QUALITY ASSURANCE -- NON-CONFORMANCE REPORT

Report No: NCR-000313

Reference Description: Missed UT Indication by QC, Weld SB002-012-004, Segment 1BW

Job Name: SAS Superstructure

WELD NUMBER: SB002-012-004

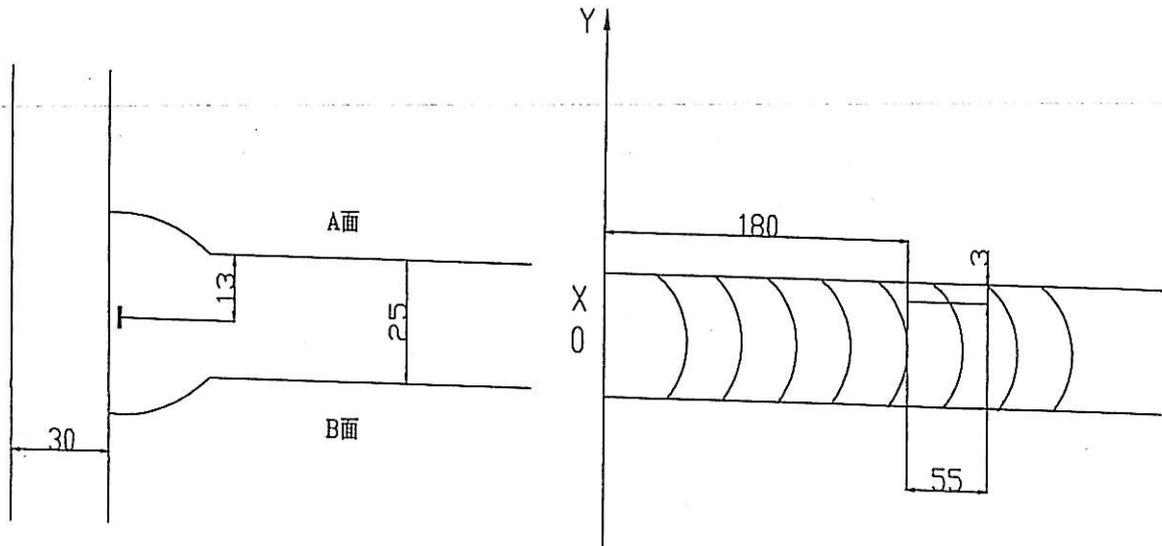
Description of welding discontinuity:

Rejected indication found by ultrasonic inspection is less than the maximum allowance aggregate length.

(UT探伤发现的缺陷总长度小于最大允许长度。) SB002-012-004

Caused:

1. Did not clear the weld pass completely in time.

Disposition:

1. Gouge or grind from nearer side from metal edge ($D \leq 0.65T$, " D " is depth of defects, " T " is thickness of metal) to remove all defects;
2. Follow repair WPS for joint preparation, preheat, and weld deposit;
3. Verify with VT no defects remain in the weld joint prior to welding;
4. Grind the repaired area flush with base metal or the adjacent weld;
5. Check the welds according to the working drawings.
